March 9, 2012

FOOD STOREROOM BUILDING RENOVATIONS at ARUBA SURF CLUB

ADDENDUM NO. 3 (Post Bid VE)

A WALK-IN COOLER AT HINGED DOOR ENTRANCE
FS1.0 | FS1.0 NOT TO SCALE

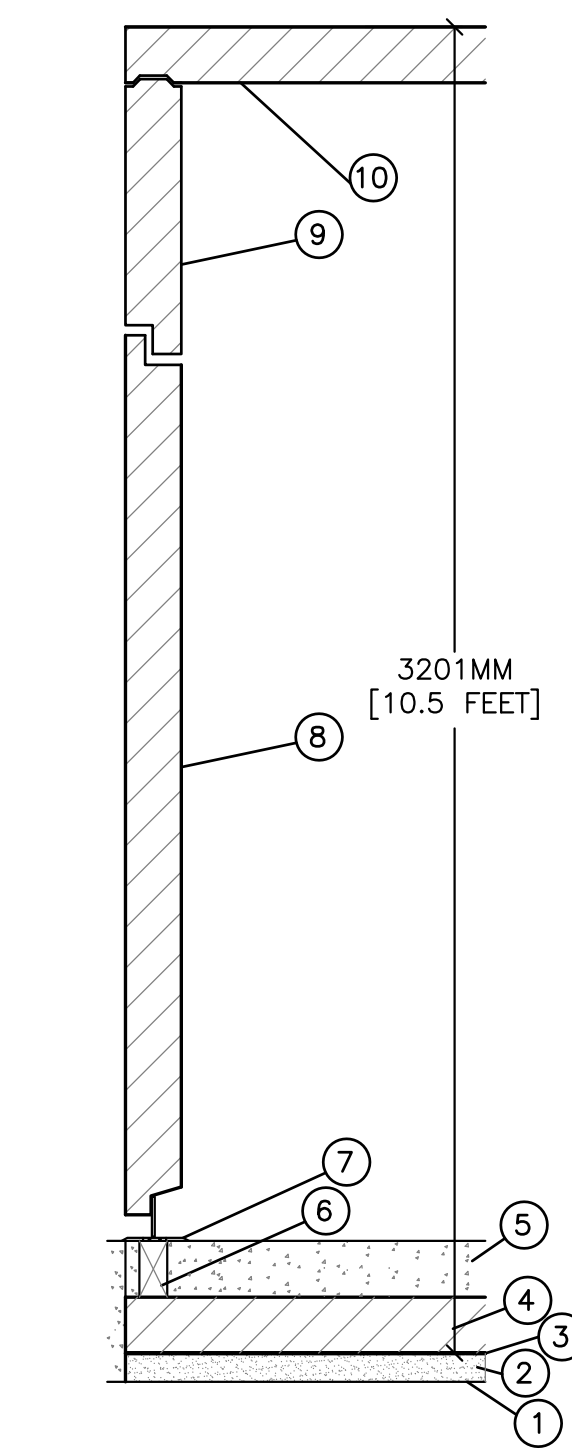
- Details A, B & C shall be revised to delete the concrete topping slab and 2" sand/mortar bed. See attached revised detail cooler-freezer floor detail.
- Change ceiling light fixture per the attached Project Requirement Revisions Item #3. Change the lighting fixture quantity and layout to match lighting layout on sheet E3.0
- Shelving in the in the Cooler, Freezer, Dry Storage A & B and Beverage Storage shall be in the quantities and types as indicated on the attached Shelving Requirements spreadsheet and Project Requirement Revisions Item #5. Coordinate layout with the Owner's representative in the field

DELETE CONCRETE TOPPING AND SAND BED. SAW CUT/ CHIP AND PATCH EXISTING CONCRETE TO INSTALL HEAT TRACE AND CONDUIT AT FREEZERS ONLY.

B WALK-IN COOLER/FREEZER AT PARTITION WALL
FS1.0 | FS1.0 NOT TO SCALE

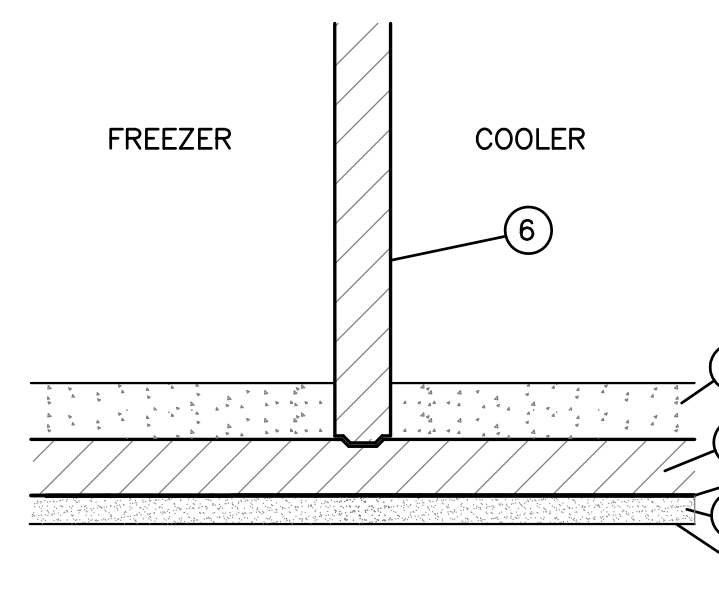
DELETE CONCRETE TOPPING AND SAND BED. SAW CUT/ CHIP AND PATCH EXISTING CONCRETE TO INSTALL HEAT TRACE AND CONDUIT AT FREEZERS ONLY.

C WALK-IN COOLER/FREEZER AT BUILDING WALL
FS1.0 | FS1.0 NOT TO SCALE

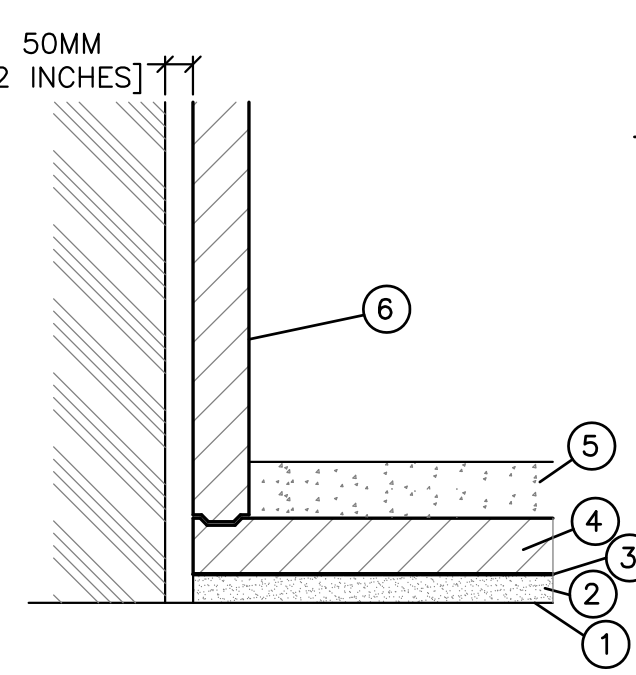
DELETE CONCRETE TOPPING AND SAND BED. SAW CUT/ CHIP AND PATCH EXISTING CONCRETE TO INSTALL HEAT TRACE AND CONDUIT AT FREEZERS ONLY.

1 WALK-IN COOLER/FREEZER AND DRY STORAGE FLOOR PLAN
SCALE 1:50

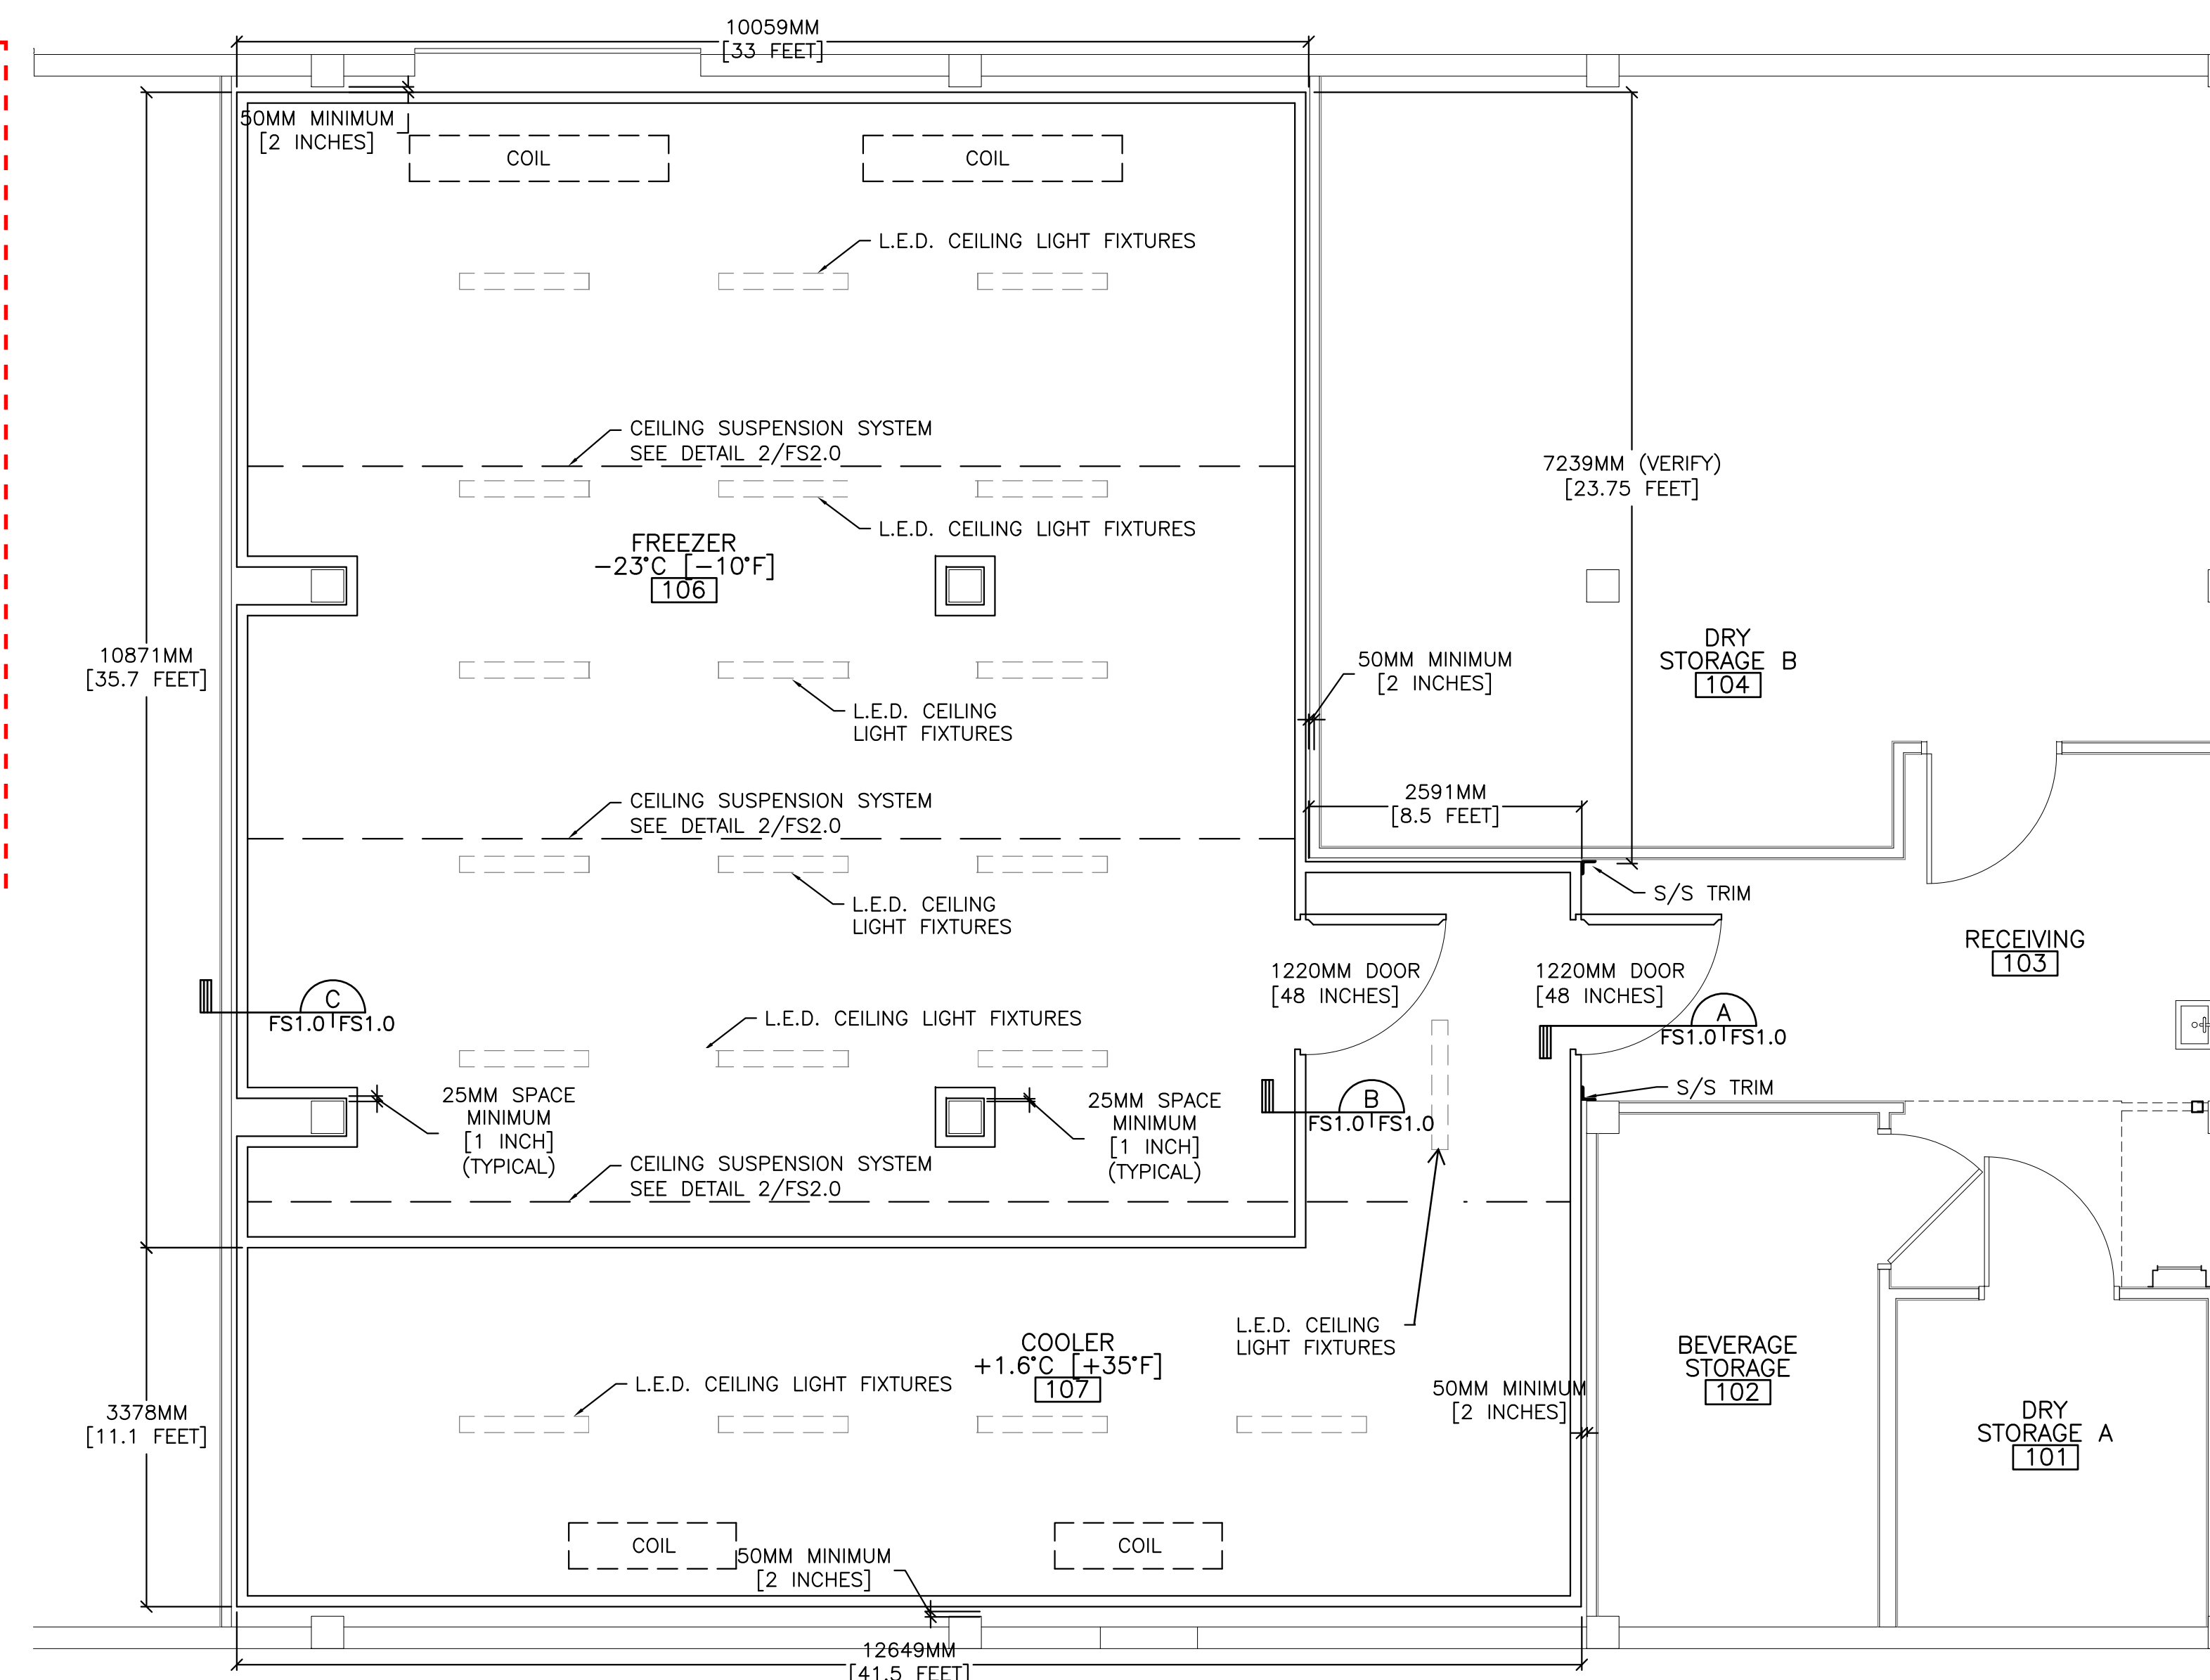
CHANGE ALL LED LIGHTING IN COOLER/FREEZER TO FLOURESCENT WITH COLD TEMP BALLASTS.
REDUCE THE NUMBER OF LIGHTS TO MATCH LIGHTING SHOWN ON SHEET E3.0
PROVIDE SURFACE MOUNTED CONDUIT AND WIRING BETWEEN EACH LIGHT FIXTURE.

2. Exposed exterior wall panels shall be 26-gauge galvanized steel with mill-applied white enamel.
3. Quantity of ceiling light fixtures shall be reduced to a quantity of twenty-one (21) Kason No. 1810EX12481L 1220 mm (48-inch) long fluorescent type with low temperature ballasts and Kason No. F54T5HO bulbs.

3 REMOTE CONDENSING UNIT PACKAGE (LOCATED ON MEZZANINE LEVEL AT RECEIVING ENTRANCE)
FS2.0 NOT TO SCALE

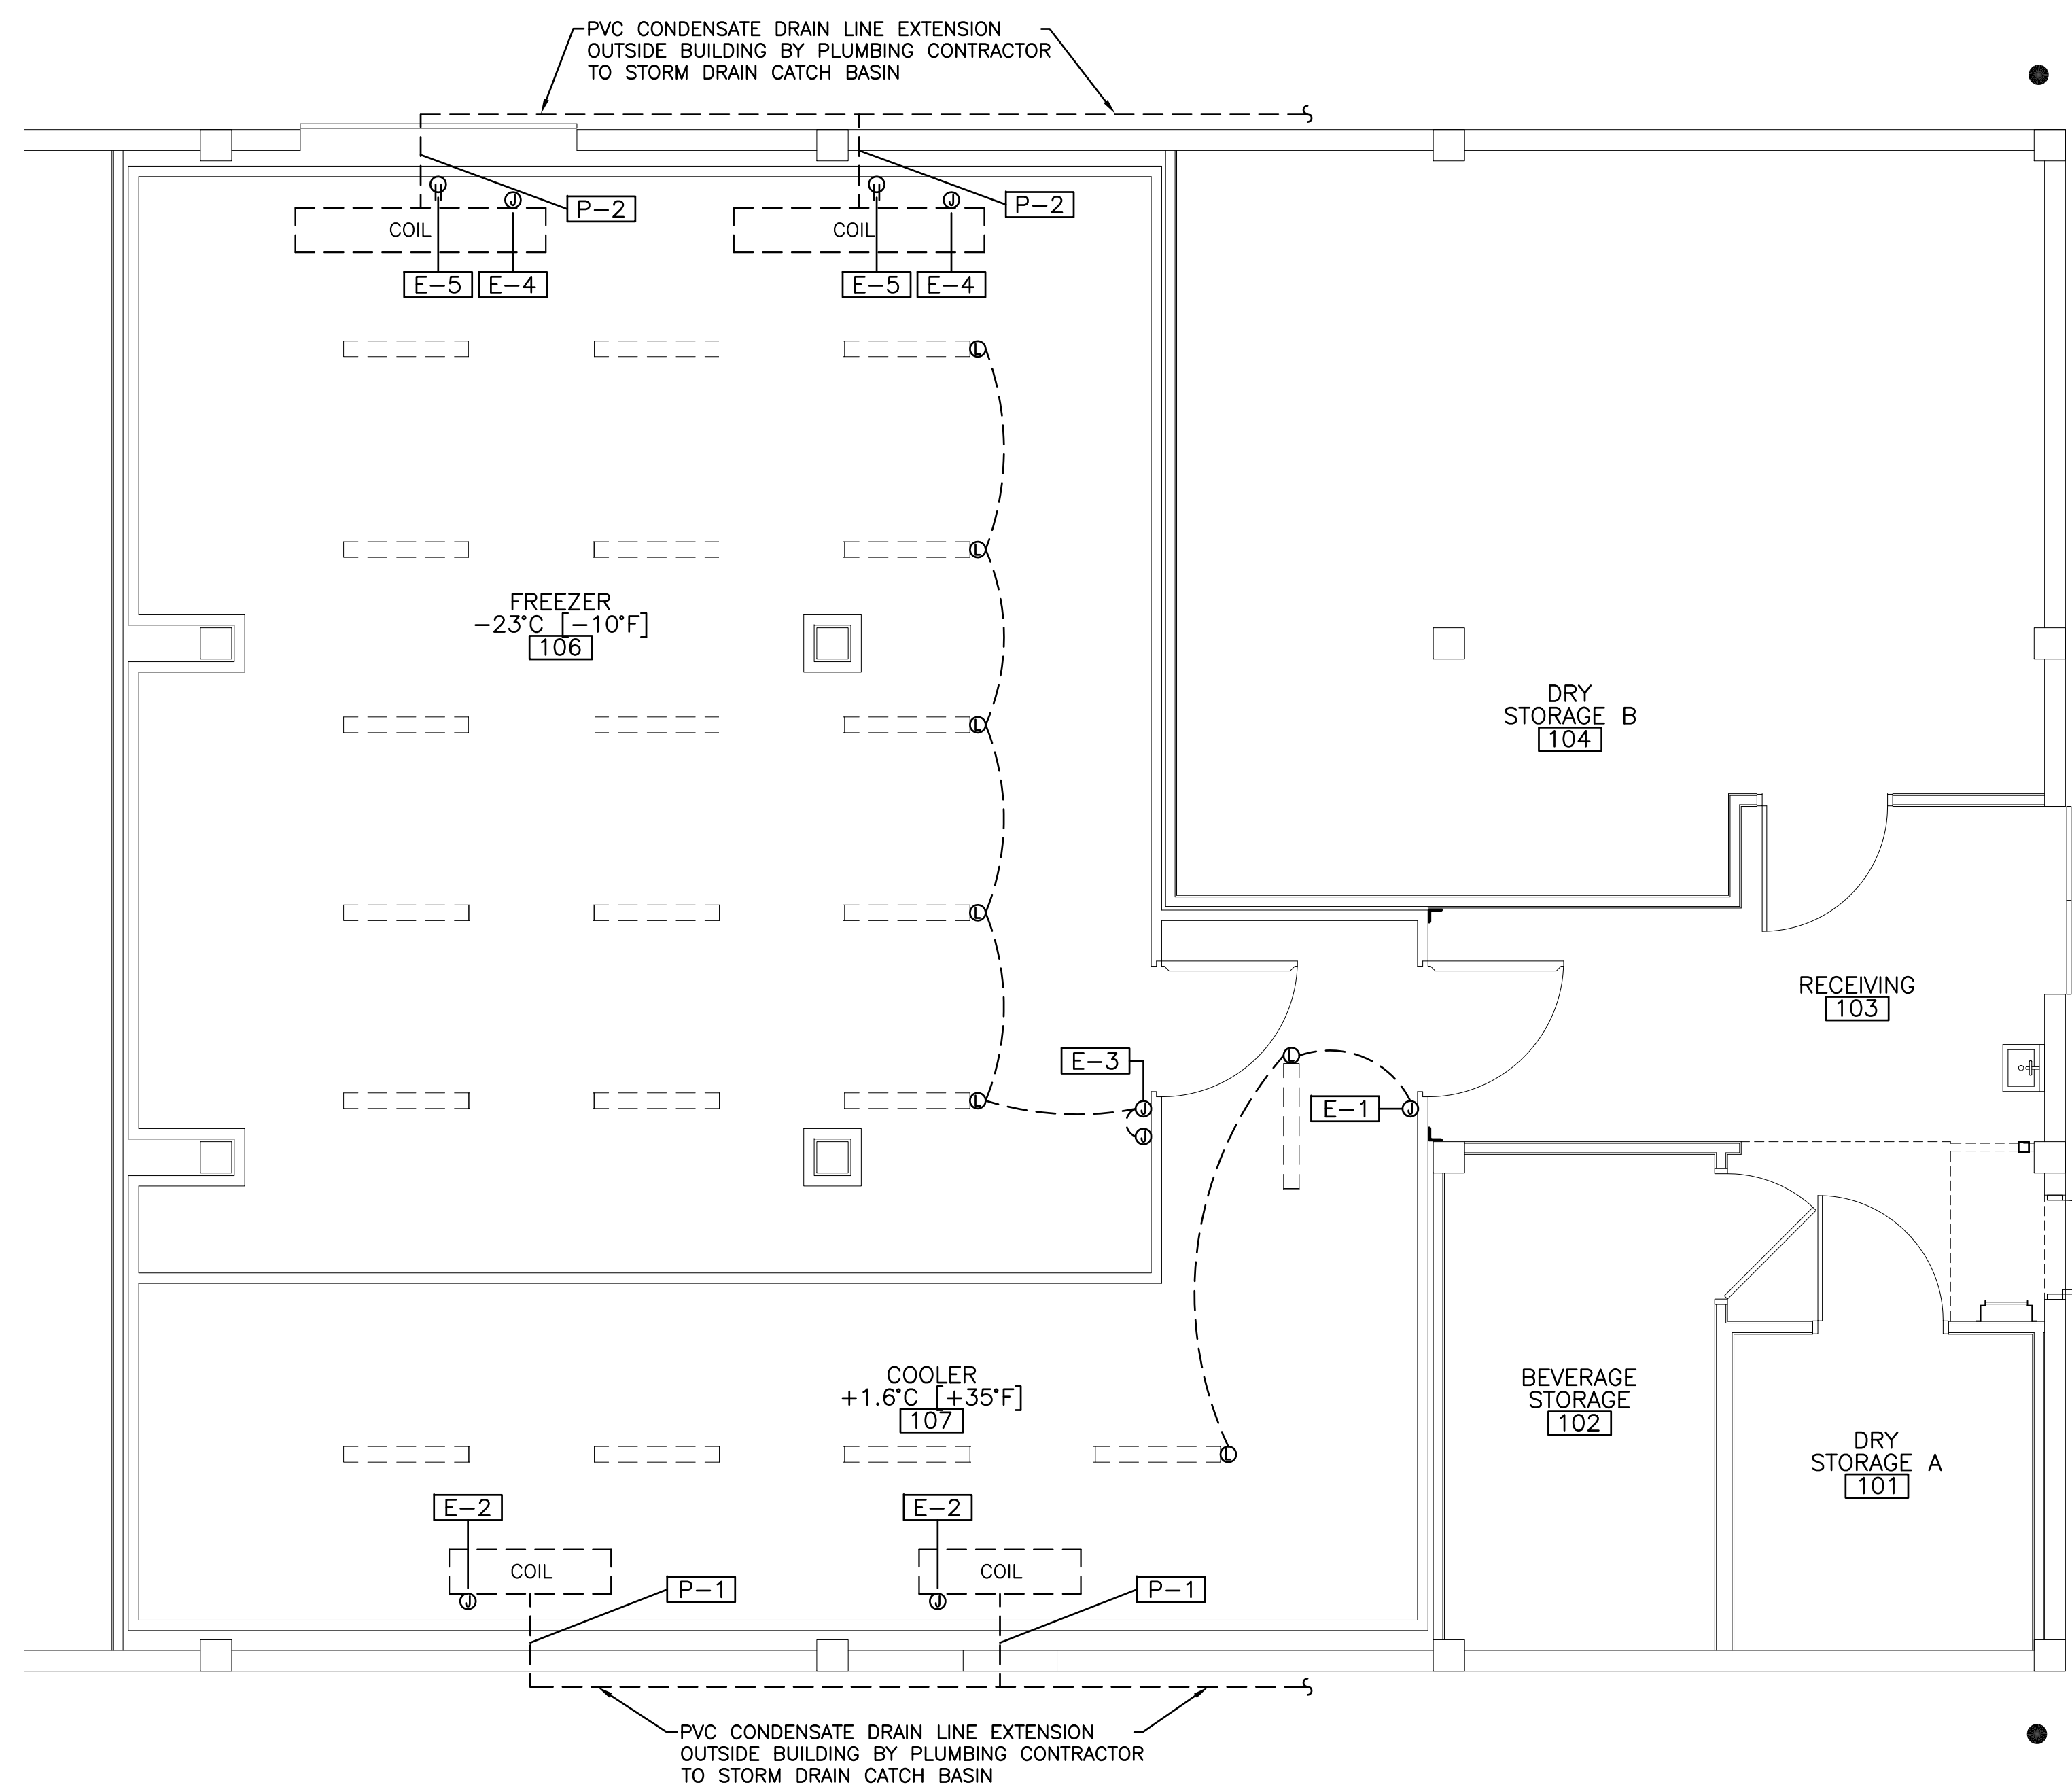
- Change the remote condensing package unit per the attached Project Requirement Revisions Item #4.

CHANGE TO 480V 3 PH AIR COOLED EQUIPMENT LOCATED ON THE ROOF

4. Remote Walk-In Cooler/Freezer Condensing Unit Package shall be RDT No. ZS2-6 (14379) with three (3) compressors, air-cooled type with condenser protective coating for salt water environment, designed for 480/3ph electrical service, and mounted on building roof.
